PROJECT NAME: St. Lawrence Townhouses

PROPOSED DEVELOPMENT ADDRESS:
71 St. Lawrence St.

PROJECT DESCRIPTION:
Two (2) Unit residential development w/private parking

Thank you for submitting an application for a proposed building construction for the property at 71 St. Lawrence Street. Your application is being reviewed for conformance with applicable zoning requirements and the standards for Site Plan (Article V) of the Portland City Code, and the Design Principles and Standards for R-6 Infill Development. The City review staff has reviewed your application materials and site plans and has the following requests and preliminary comments:

DRAWING: ARCHITECTURAL SITE PLAN

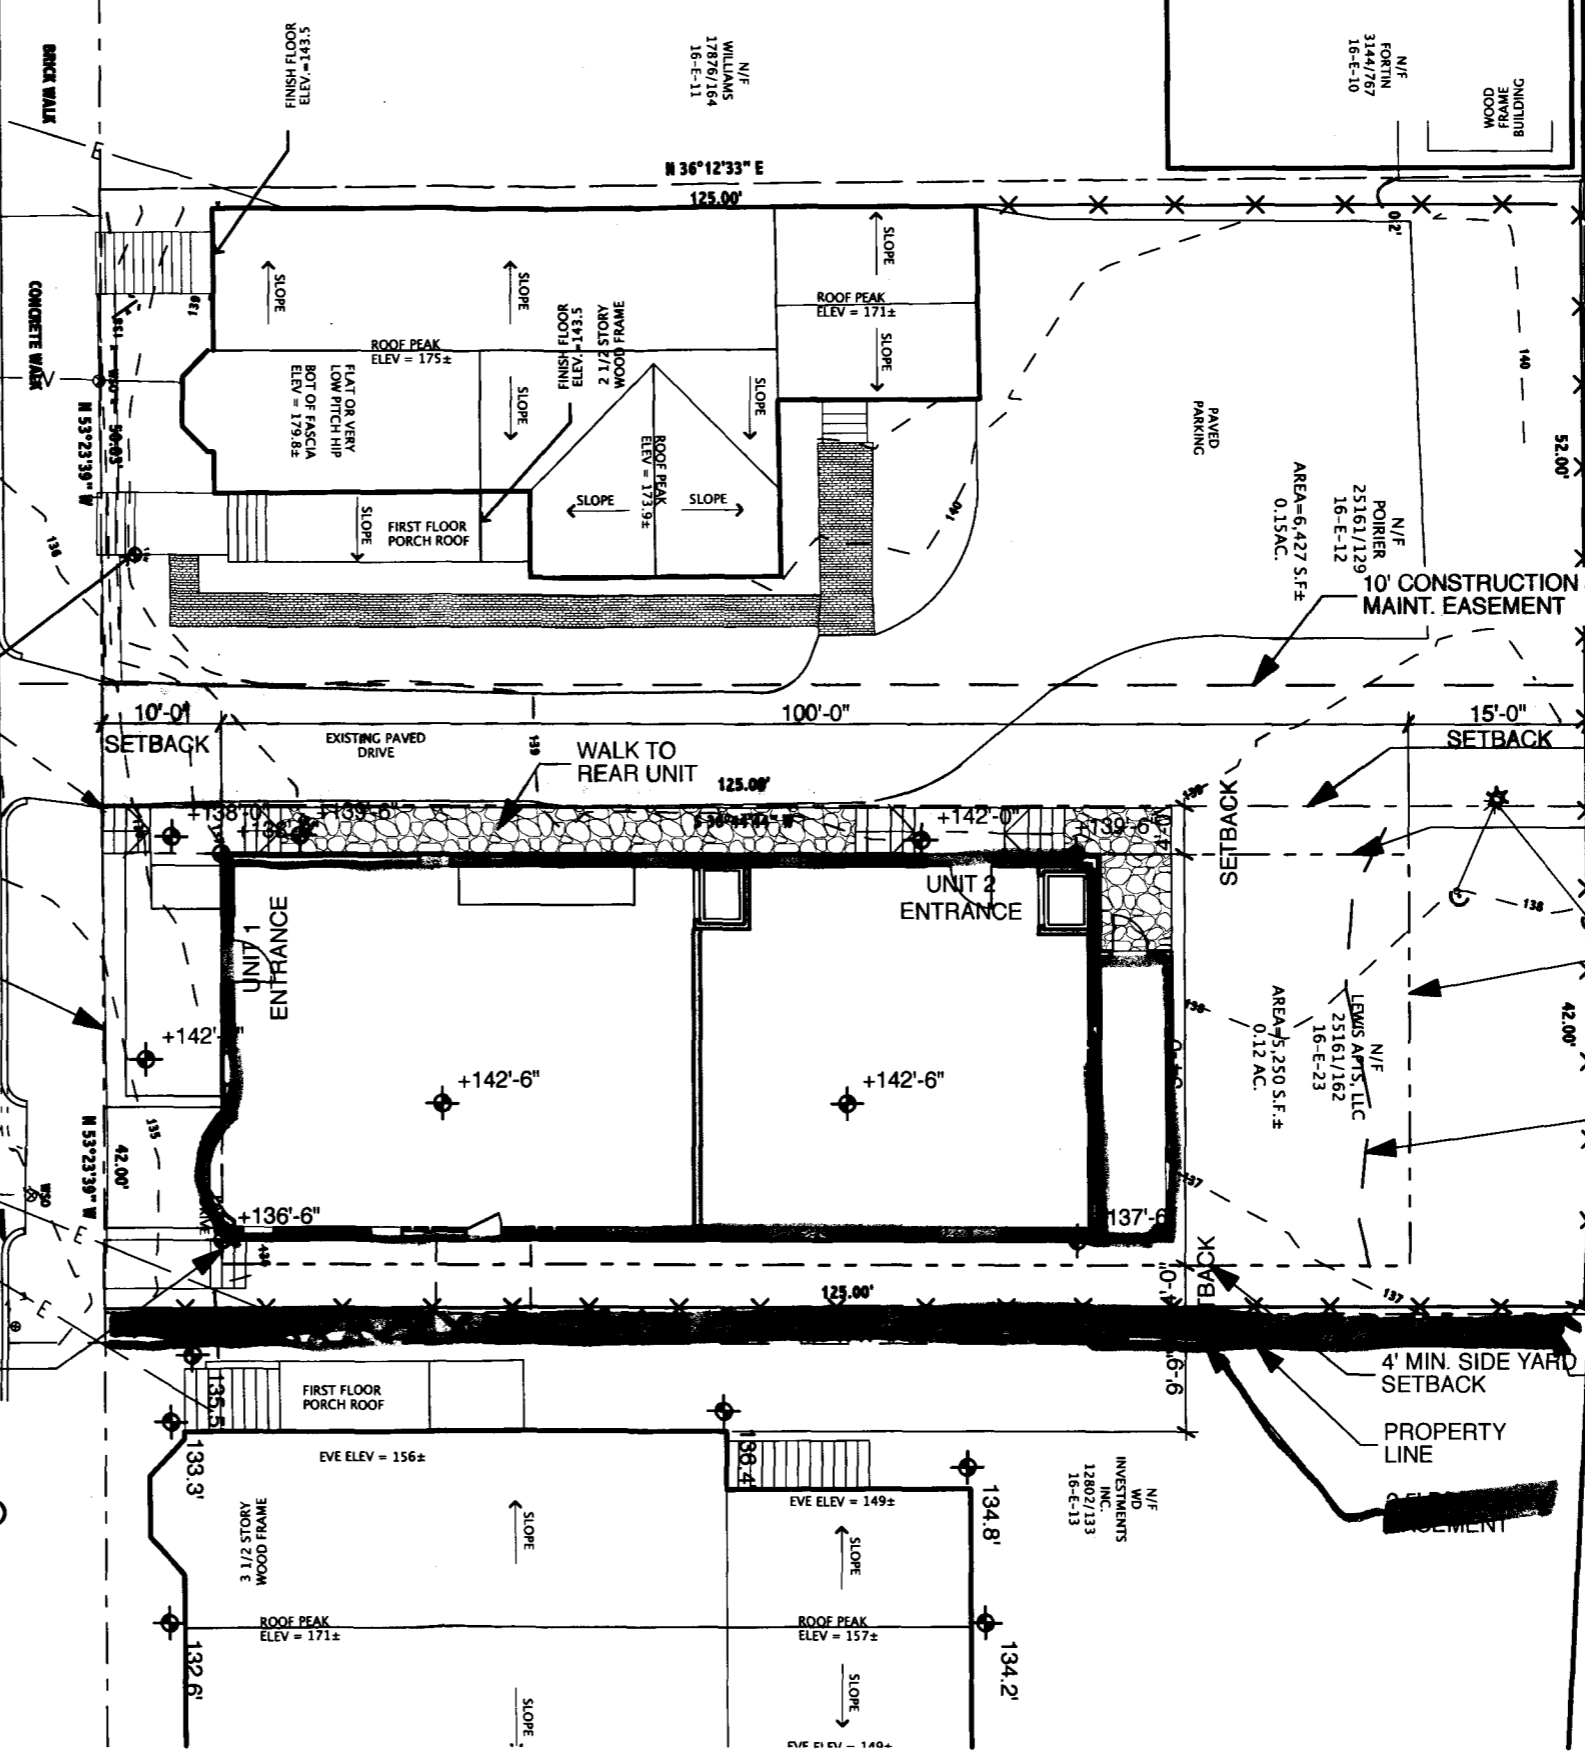
1. Complete copy of the warranty deed
2. Directional arrow on all site plans
3. Scalable plan that uses the engineer scale instead of the architectural one
4. Would the existing paved drive be removed?
5. Sidewalk material for the Portland Peninsula is brick
6. Keep the existing coniferous trees in the back, if to be removed then some kind of landscaping should be proposed.
7. Parking aisle widths are proposed at 10x18, the City standards is 9x19. Applicant can ask for a waiver of this standard with an explanation.
8. Submit material samples and descriptions for review
9. There is an existing lighting pole in the back of the parcel, will this stay?

DRAWING: BASEMENT PARKING

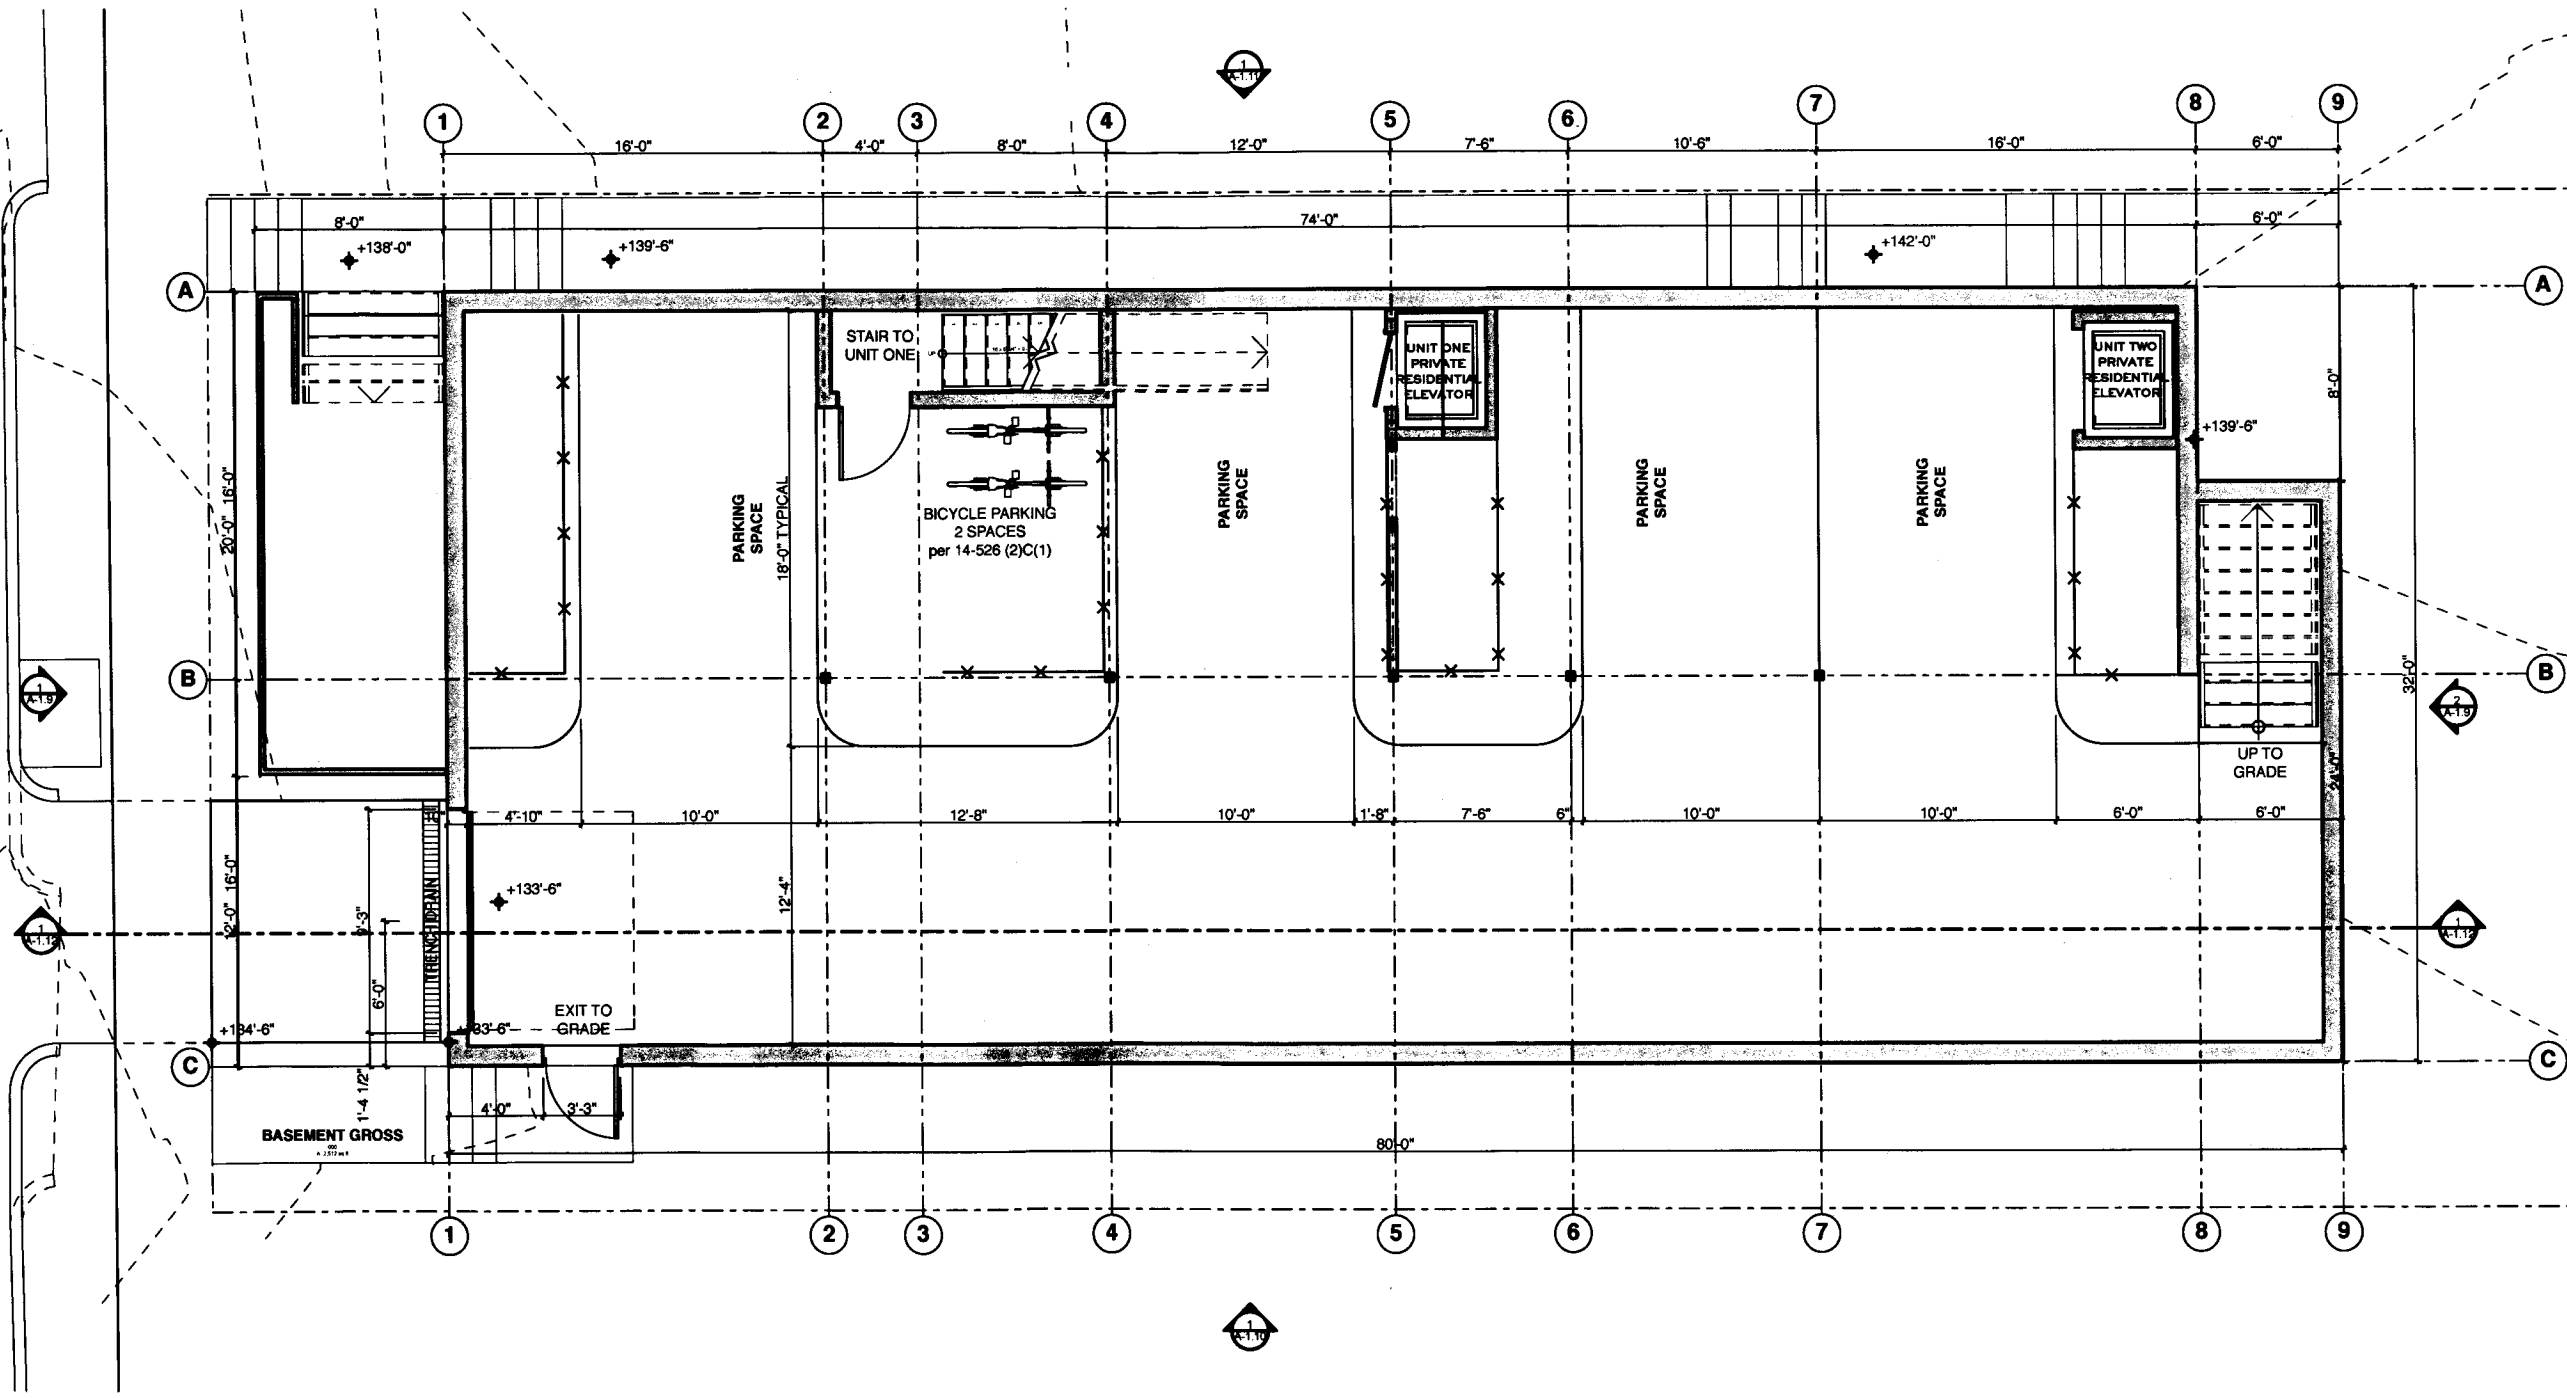
- The driveway/garage door opening shall have a minimum width of 10 feet. The plans indicate a width of 9 feet 3 inches.
- The parking aisle width is 12 feet 4 inches and may not provide adequate room for maneuvering. The applicant shall provide an "auto-turn" template that illustrates passenger cars can access and egress the proposed parking spaces.
